## **Site Accessibility Evaluation**

# Americans with Disabilities Act And ANSI A117.1

Taco Bell Store #24647 (Pre)

**Pre Inspection**

#### Finding: 4

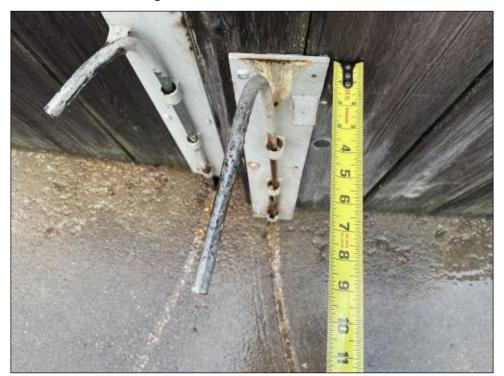
The element projects more than 4 inches into the circulation path.

Wall-mounted objects that have leading edges between 27 inches and 80 inches from the floor must not project more than 4 inches into the circulation path. Protruding objects that extend to the floor or within 27 inches of the floor are cane detectable and are therefore not hazardous. Where it is necessary or desirable to have objects protrude from the wall, a manner of cane detection must be provided.

2010 ADAS Section: 307.2 4"-9" (handles)

## Finding: 5

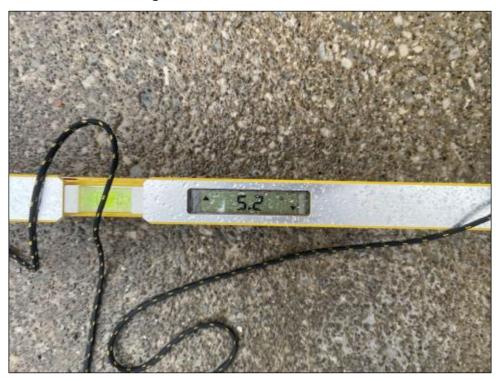
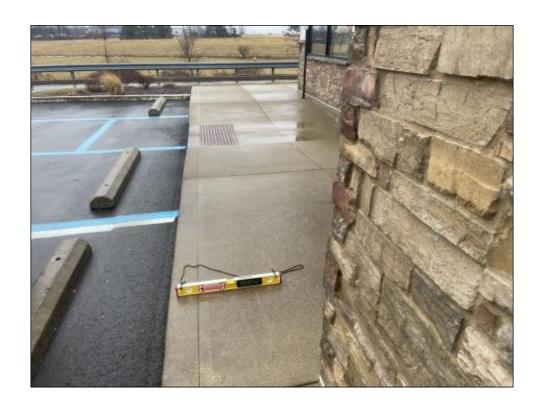
The accessible path of travel between the building and the public way on the site has cross slopes greater than 2%.

Surface cross slopes shall not exceed one unit vertical in 48 units horizontal (2-percent slope).

2010 ADAS Section: 403.3 4.1%-7.5%

## Finding: 9

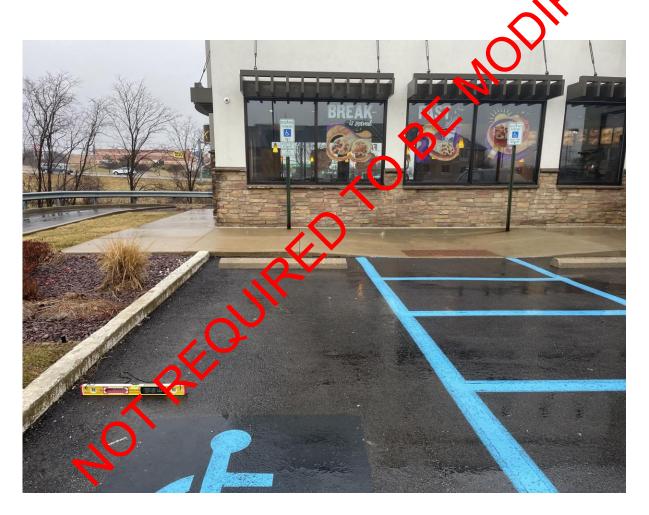
The cross slope (narrow dimension) of the parking stall exceeds 2%.

The running and cross slope in an accessible parking stall and the access aisle must not exceed 2%.

2.6% (24"x24")

## WITHIN REASONABLE CONSTRUCTION TOLERANCE

Finding: 10

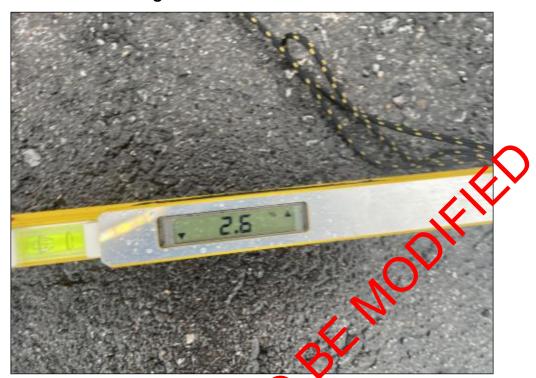
The running slope of the access aisle (long dimension) exceeds 2%.

The running slope in an accessible parking stall and the access aisle must not exceed 2%.

2010 ADAS Section: 502.4 3.2%

## Finding: 11

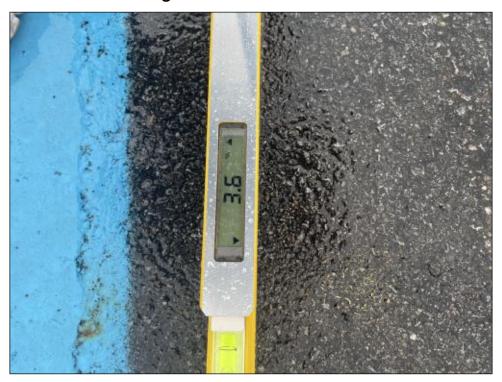
The running slope (long dimension) of the accessible parking stall exceeds 2%.

The running slope in an accessible parking stall and the access aisle must not exceed 2%.

2010 ADAS Section: 502.4 2.6%-3.6%

## Finding: 14

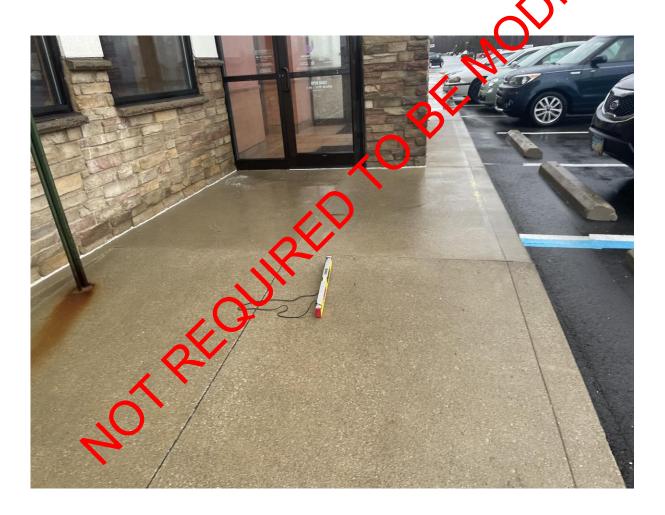
The curb ramp exceeds the maximum running slope (parallel to the direction of travel) allowable of 8.33%.

Curb ramps should have the least possible slope but in no case more than 8.33% (1:12).

2010 ADAS Section: 406.1 9.3%

## WITHIN REASONABLE CONSTRUCTION TOLERANCE

Finding: 24

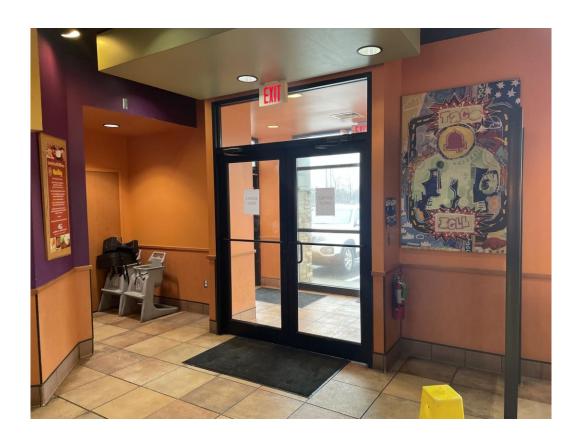
The tactile EXIT sign is missing at the door.

2010 ADAS Section: 216.4.1 Missing

Finding: 32

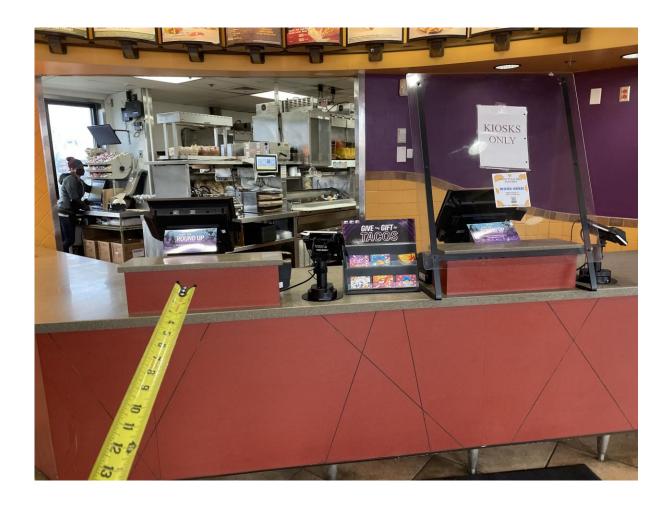
The counter is too high.

A portion of the counter surface that is 30 inches long minimum and 36 inches high maximum shall be provided. Knee and toe space shall be provided under the counter. A clear floor or ground space shall be positioned for a forward approach to the counter.

2010 ADAS Section: 904.4.2 41 3/8" to partitions

## Finding: 34

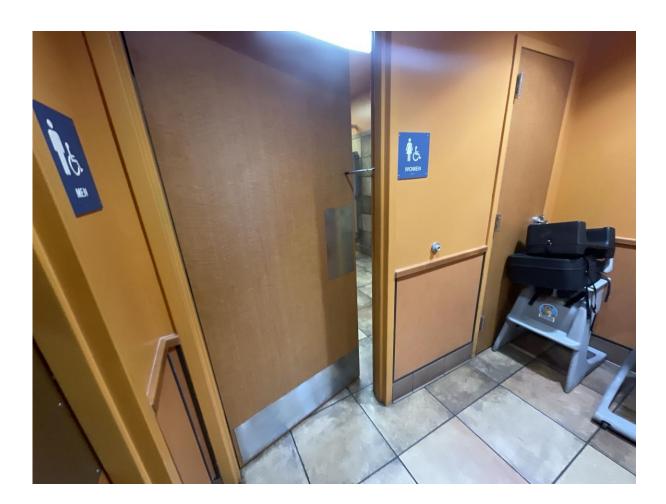
The door exceeds the maximum allowable opening force.

Interior doors shall have a maximum opening force of 5 pounds.

2010 ADAS Section: 404.2.9 10 lbs

#### Finding: 40

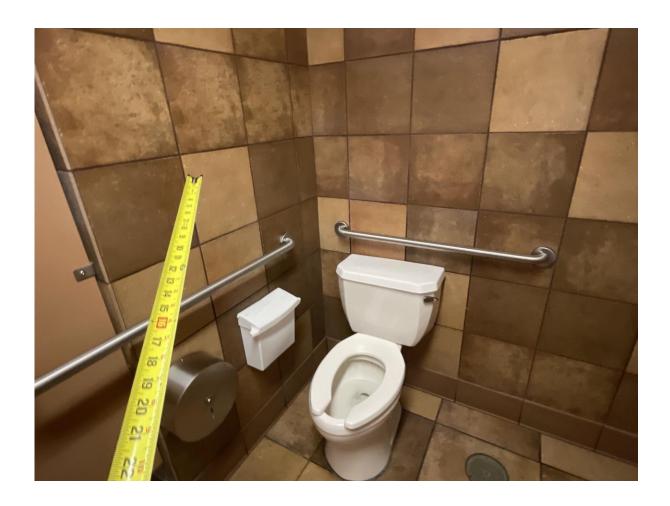
The vertical grab bar missing.

Fixed sidewall grab bars shall be 42 inches minimum in length, located 12 inches maximum from the rear wall and extending 54 inches minimum from the rear wall.

In addition, a vertical grab bar 18 inches minimum in length shall be mounted with the bottom of the bar located between 39 inches and 41 inches above the floor, and with the center line of the bar located between 39 inches and 41 inches from the rear wall.
